COLONIAL HILLS SUBDIVISION, UNIT 6

APPLICATION NUMBER 14 DATE October 2, 2008

REQUEST Subdivision

DETAIL SITE PLAN

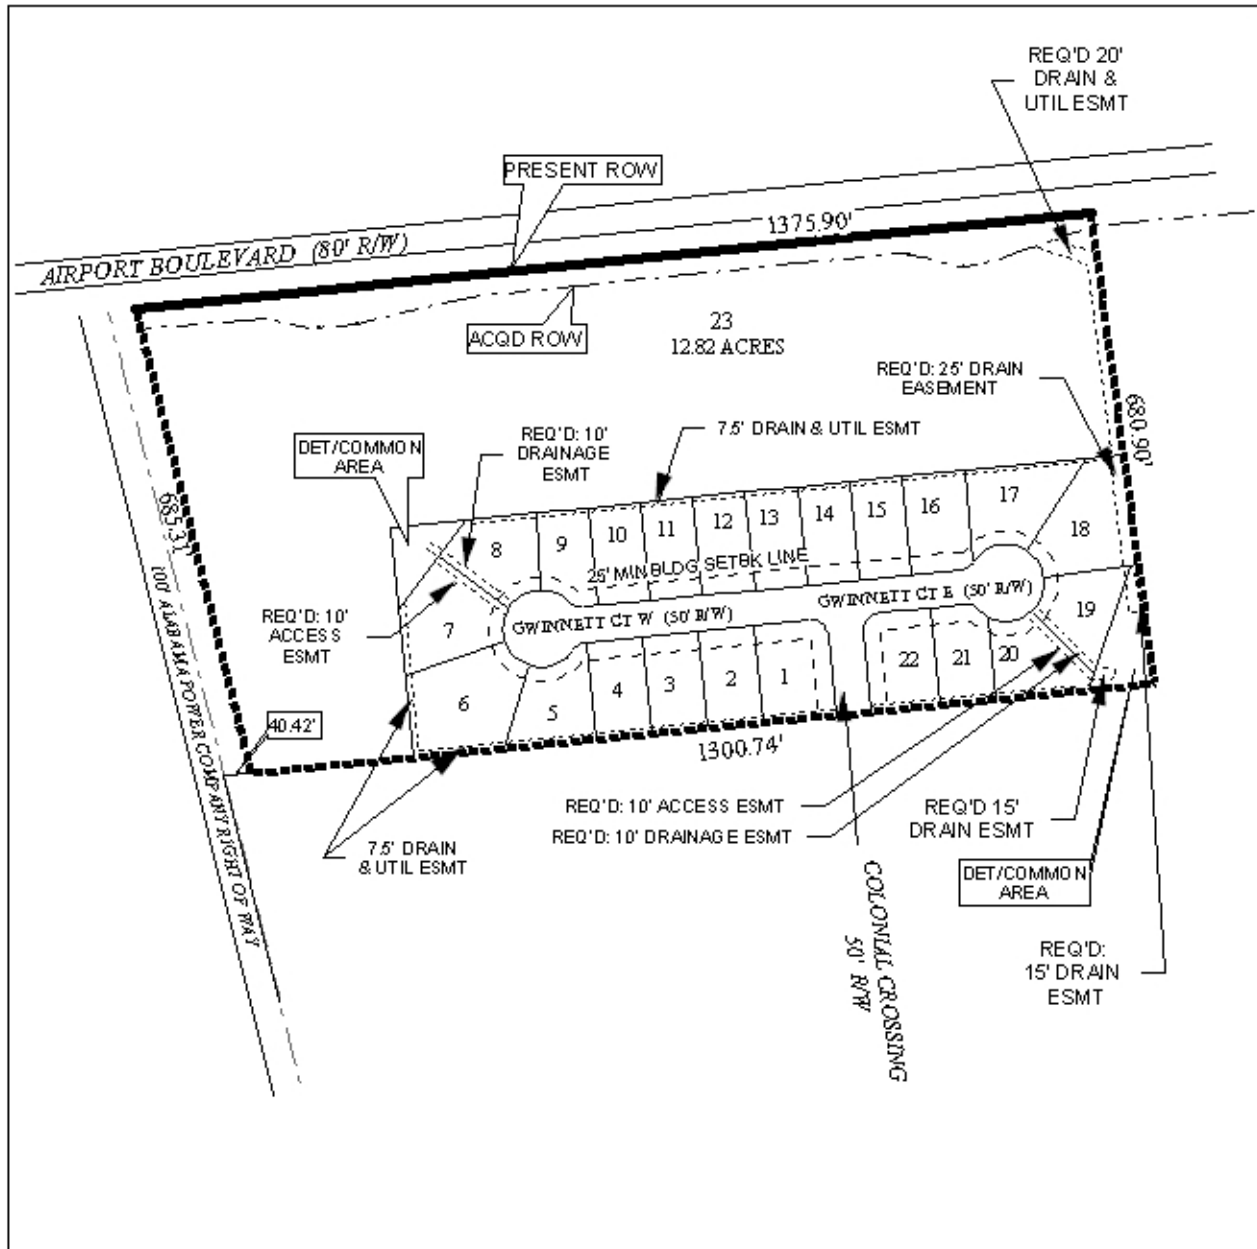
Access management is a concern due to the location of proposed Lot 23 of the development fronting onto Airport Boulevard. Lot 23 should be allowed two curb cuts to Airport Boulevard, with the size, design and location to be approved by Mobile County Engineering, and conform to AASHTO standards. However, since Lot 23 possibly will be developed commercially, and could exceed the development criteria for requiring a Traffic Impact Study, a Traffic Impact Study (TIS) should be required if the development exceeds these thresholds: 1) residential, one hundred fifty (150) dwelling units; 2) retail, twenty-five thousand (25,000) square feet; 3) office, sixty thousand (60,000) square feet; 4) industrial, ninety thousand (90,000) square feet; 5) education, thirty thousand (30,000) square feet or two hundred fifty (250) students; 6) lodging, one hundred fifty (150) rooms; and 7) medical, twenty-five thousand (25,000) square feet.

The 25-foot minimum building setback line, required in Section V.D.9., is not accurately depicted on the preliminary plat for Lot 23. The setback line should be shown for all properties, and should be from all street frontages, including the lot with frontage on Airport Boulevard. Therefore, the plat should be revised to show the correct setback from all street frontages, including the lot providing frontage onto Airport Boulevard.

While all lots appear to meet minimum size requirements, the Final Plat should be revised to label each lot with the size in square feet, or provide a table on the plat with the same information.

Finally, there appears to be an error in the written legal description and a bearing along the Western boundary of the site. It seems that the description does not include the 50-feet of the Alabama Power Company right-of-way. The plat should be revised to correct the errors.

- 1) dedication of sufficient right-of-way to provide a minimum of 50 feet from the centerline of Airport Boulevard;
- 2) placement of a note on the final plat stating if development on Lot 23 exceeds the development criteria for requiring a Traffic Impact Study, a Traffic Impact Study (TIS) should be required if the development exceeds these thresholds: 1) residential, one hundred fifty (150) dwelling units; 2) retail, twenty-five thousand (25,000) square feet; 3) office, sixty thousand (60,000) square feet; 4) industrial, ninety thousand (90,000) square feet; 5) education, thirty thousand (30,000) square feet or two hundred fifty (250) students; 6) lodging, one hundred fifty (150) rooms; and 7) medical, twenty-five thousand (25,000) square feet;

- 3) placement of a note on the final plat stating that Lot 32 is limited to a maximum of two curb-cuts onto Airport Boulevard, with the size, design and location to be approved by Mobile County Engineering and conform to AASHTO standards;

- 4) placement of a note on the final plat stating that Lot 1 & 22, corner lots are limited to one curb cut each, with the size, design and location to be approved by County Engineering and conform to AASHTO standards;

- 6) revision of the plat to ensure that the 25-foot minimum building setback line is accurately depicted as 25-feet, as adjusted for right-of-way dedication for Airport Boulevard, for all lots with frontage on a public street;

- 7) certification via placement of a note on the plat stating that the property owner/developer will comply with all local, state and federal regulations regarding endangered, threatened or otherwise protected flora and fauna;
- 8) provision of a certification letter from a licensed engineer to the Planning Section of Urban Development, certifying that the stormwater detention and drainage facilities comply with the City of Mobile stormwater and flood control ordinances, prior to the signing and recording of the final plat;
- 9) labeling of all lots with size in square feet, or provision of a table with the lot size information on the plat; and
- 10) correction of the written legal description and the labeled bearings along the Western boundary of the development to include the 50-feet of the Alabama Power Company right-of-way.
